Access Compliance Report

Public Rights-of-Way

(Curb Ramps)

Intersection ID: 44071	Main Street: NEWLANDS_CORNER_LN	Cross Street: SEDGEMOOR_LN	Location: SE
ADA ID: B05B589DDC13	Ramp Type: PerpDiag	Initial Pass/Fail: Fail	Overall Compliance: No
Severity Score: 18.75			
Codes/Mitigation Info/Possible Solution		Field Measurements/Component Compliance

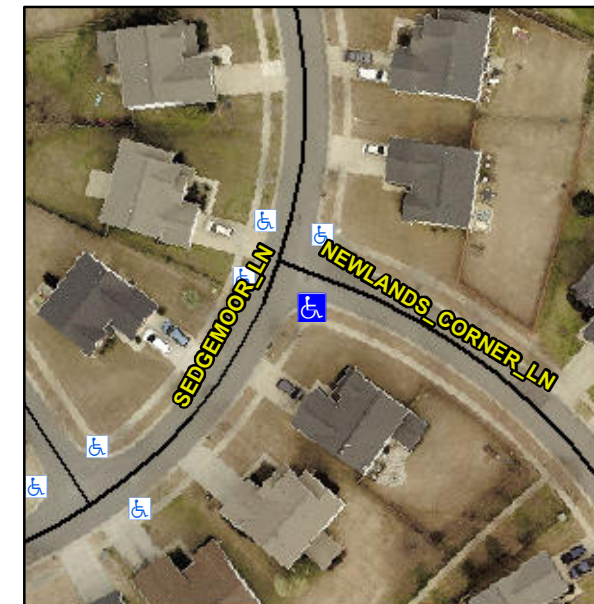
R304.5.1, R304.5.3

Compliance	Description	Data	Compliance	Description	Data
N/A	Ramp Length (in)	66.0	Yes	Ramp Slope (%)	5.9
No	Ramp Width (in)	35.0	No	Ramp XSlope (%)	2.3
N/A	Flare Type LT	N/A	N/A	Flare Type RT	N/A
N/A	Flare Slope LT (%)	N/A	N/A	Flare Slope RT (%)	N/A
N/A	Flare Traversable LT?	N/A	N/A	Flare Traversable RT?	N/A
N/A	Landing Length (in)	N/A	N/A	DWS Provided?	N/A
N/A	Landing Width (in)	N/A	N/A	DWS Contrast?	N/A
N/A	Landing Slope (%)	N/A	N/A	DWS Length (in)	N/A
N/A	Landing X Slope (%)	N/A	N/A	DWS Full Width?	N/A
N/A	Landing Curb? (Y/N)	N/A	N/A	DWS Offset (in)	N/A
N/A	Shared Landing?	N/A			
N/A	Gutter Ponding?	N/A	N/A	Gutter Slope (%)	N/A
N/A	Gutter Lip Ht (in)	N/A	N/A	Gutter X Slope (%)	N/A
N/A	Painted X Walk1?	No	N/A	Painted X Walk2?	No
	X Walk 1 Direction	To NE		X Walk 2 Direction	To NW
N/A	X Walk 1 Width (in)	N/A	N/A	X Walk 2 Width (in)	N/A
	X Walk 1 Slope (%)	0.8		X Walk 2 Slope (%)	5.9
	X Walk 1 X Slope (%)	4.1		X Walk 2 X Slope (%)	0.2

Remove & Replace Curb Ramp With Two New Directional Ramps or Equivalent.
